Elexicon Energy Inc.

Answer to Interrogatory from

OEB Staff

Figure 1: North Brooklin development area relative to existing MS and TS in Whitby

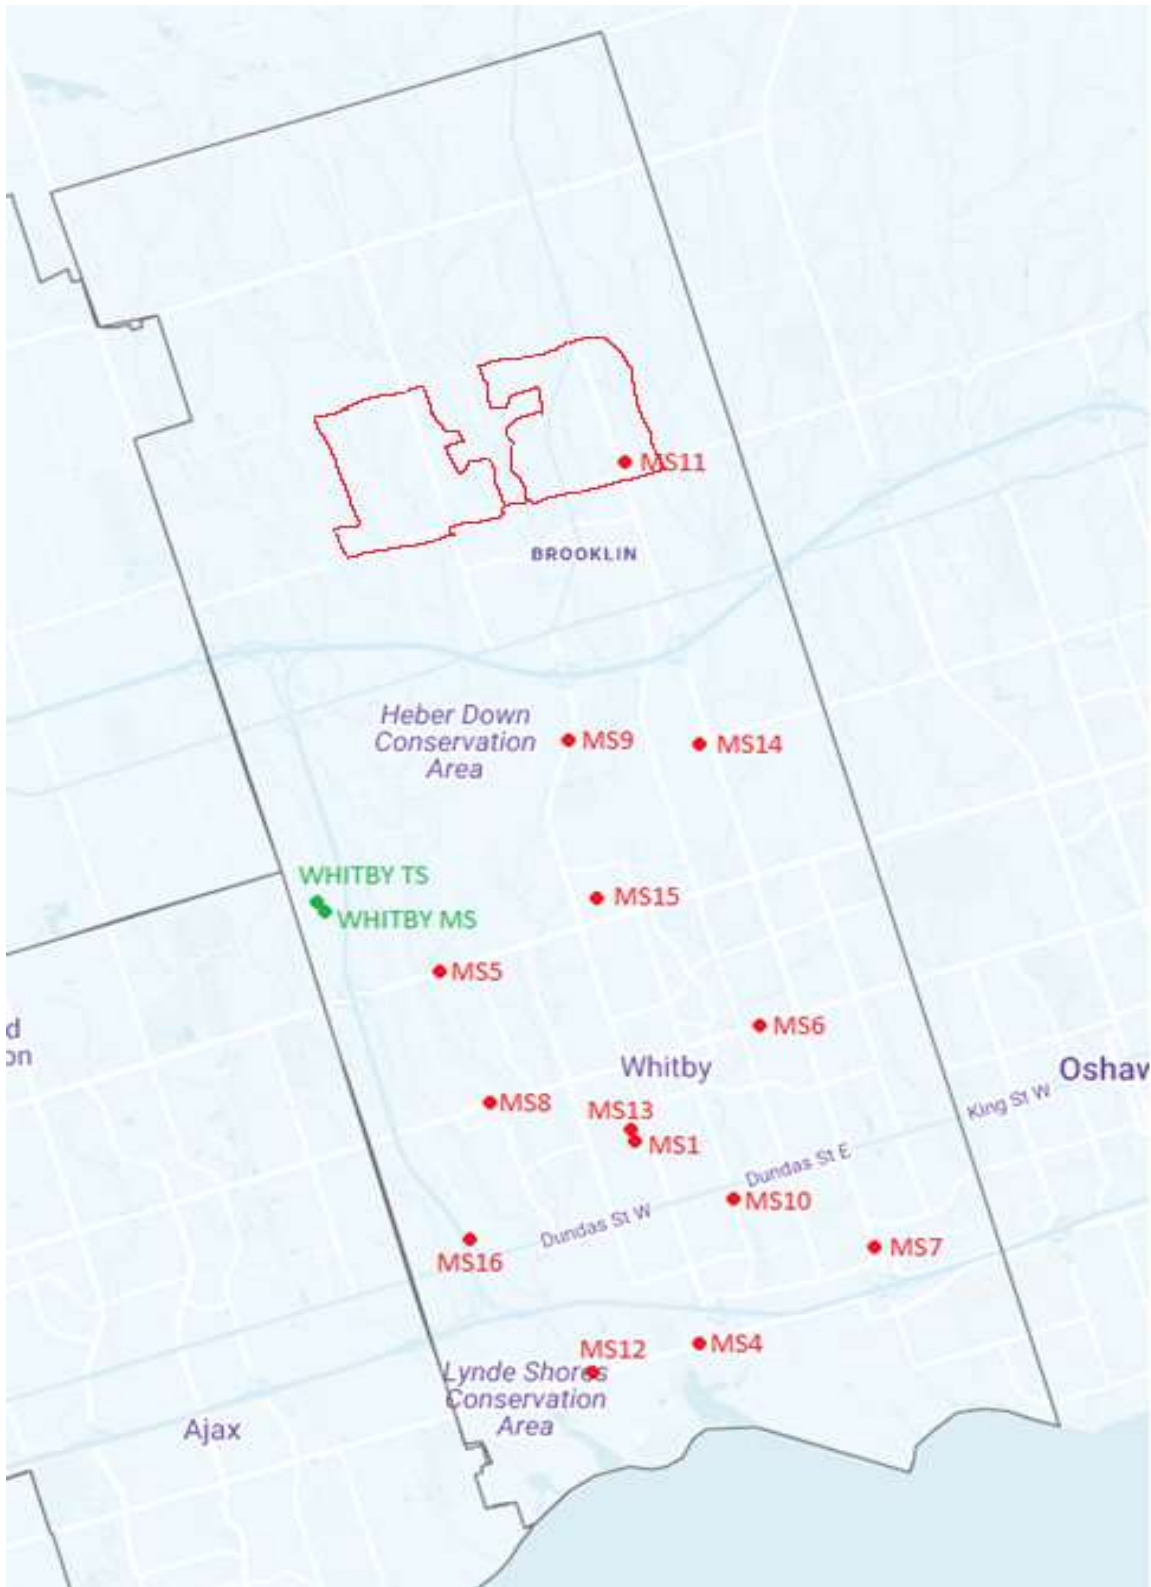
- f) Please provide the following information for the transformer and distribution stations in the Brooklin area. The station name, station capacity, station voltage, number of transformers, age of transformers, and asset condition assessment of transformers.

f) The closest Transformer Station (“TS”) to the Brooklin area is Whitby TS owned by Hydro One Networks Inc. (“HONI”). HONI determines available capacity as the summer ten-day limited time rating (“LTR”) in MW at the TS bus level. Specifically, Whitby TS has three buses which are each a Dual Element Spot Network (“DESN”). Four transformers supply these three buses at Whitby TS. Table 1 summarizes the voltage levels and ratings of these buses. Since the transformers are HONI-owned, Elexicon does not track their age or condition, nor are those parameters reported during the Regional Planning Process.

Figure 1 shows a map of the MS and TS within the Whitby Rate Zone and depicts the proposed North Brooklin development area for new housing projects in red, as adapted from Map 2 of the *Brooklin Study Secondary Plan*.
